Amendments to the Drawings:

Application No. 10/800,844
Reply to Office Action of May 4, 2005
Annotated Marked-Up Drawings

FIG. 3

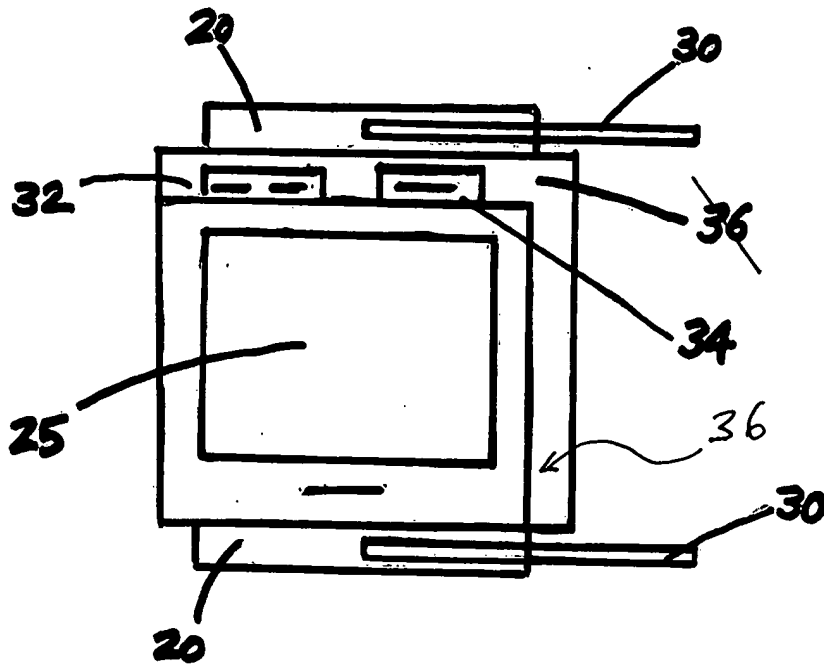
~~10~~
